# Work Order ID 114848

Item Name: Crosstube Turning Detail

DRAWING NO. D412-664-243	TITLE CROSSTUBE ASS'Y (412 HI AFT)	REV. E	DART AEROSPACE LTD ENGINEERING ORDER		D.E.O. NO. D412-664-243-E-2	SHEET NO. SHEET 1 OF 1	SCALE NTS
DRAWN 97	CHECKED ASS	MFG. APPR. RE	APPROVED MP		DE APPR. #		
DATE 11.09.07	DATE 11.09.19	DATE 11.09.19	DATE 11.09.19		DATE 11.09.19

DRAWING NO. D412-664-243	TITLE CROSSTUBE ASSEMBLY (412 HI AFT)	REV. E	DART AEROSPACE LTD ENGINEERING ORDER		D.E.O. NO. D412-664-243-E-4	SHEET NO. SHEET 1 OF 3	SCALE NTS
DRAWN 90	CHECKED A	MFG. APPR. A	APPROVED MP		DE APPR. MP		
DATE 12.08.21	DATE 12.08.30	DATE 12.08.30	DATE 12/8/30		DATE 12.08.30

DRAWING NO. D412-664-243	TITLE CROSSTUBE ASSEMBLY (412 HI AFT)	REV. E	DART AEROSPACE LTD ENGINEERING ORDER		D.E.O. NO. D412-664-243-E-4	SHEET NO. SHEET 2 OF 3	SCALE NTS
DRAWN 90	CHECKED	MFG. APPR.	APPROVED		DE APPR.		
DATE 12.08.21	DATE 12.08.27	DATE 12.08.29	DATE 12.08.29		DATE 12.08.29

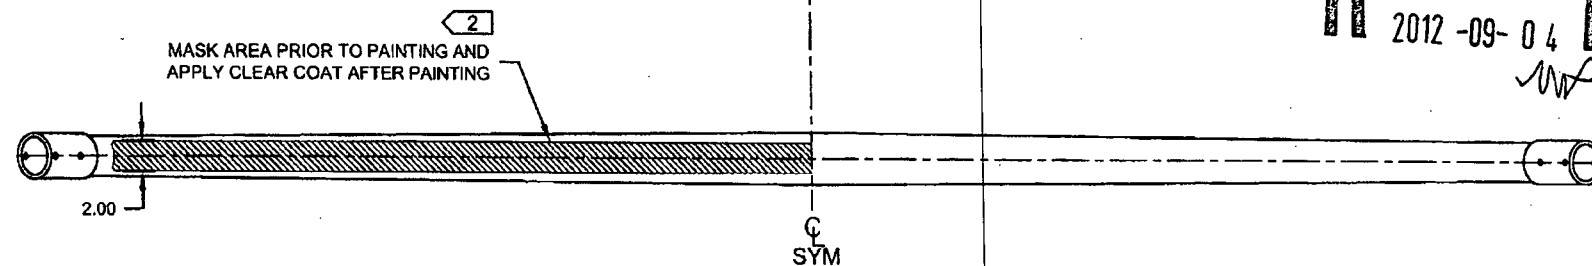
REMOVED ABRASION STRIP IN FAVOR OF A THIN LAYER OF PROSEAL 890. UPDATE INSTALLATION OF CHAFING SHIELDS AND REDUCE TORQUE TO 40-50 IN-LBS. THIS ENGINEERING ORDER SUPERCEDES DEO D412-664-243-E-1.

**WAS:**

D2856-600-1009 ABRASION STRIP  
D3189-1 CHAFING SHIELD (1, INSTALLED OVER ABRASION STRIP)  
MS21920-28 CLAMP, 2X  
2 PL

**IS:**

D3189-1 CHAFING SHIELD (1, INSTALLED OVER PROSEAL 890)  
MS21920-28 CLAMP, 2X  
2 PL
